Technical Bulletin

Brava Slate Roof System Update

Published January 19, 2024

Brava Slate Hip & Ridge Cap Redesign

Previous vs Updated Caps

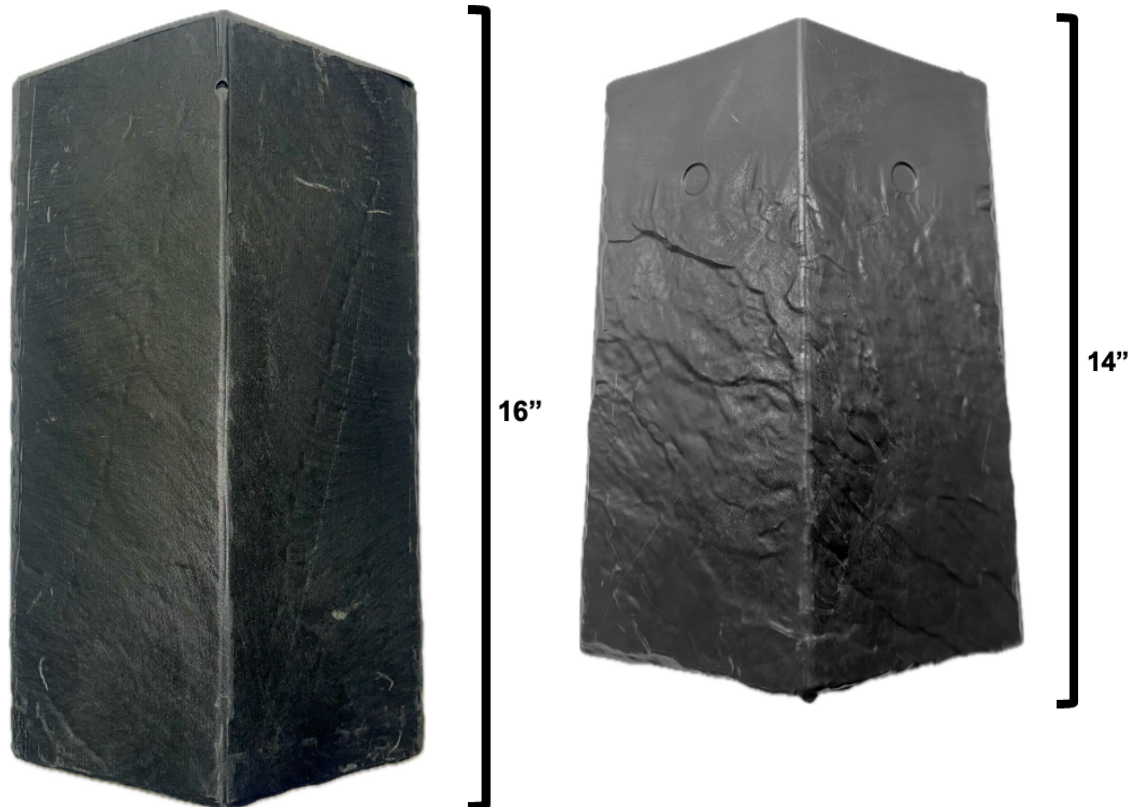
The updated Brava Slate Hip & Ridge Cap is available in three optional slope angles – Low Slope, Standard Slope, and Steep Slope – and a deeper, more striking slate appearance. All the updated parts are produced with a 14" overall length versus the previous 16" length.

Previous Hip & Ridge Cap – 16" Length

New Hip & Ridge Cap – 14" Length

For a consistent appearance, the two versions should not be installed together.
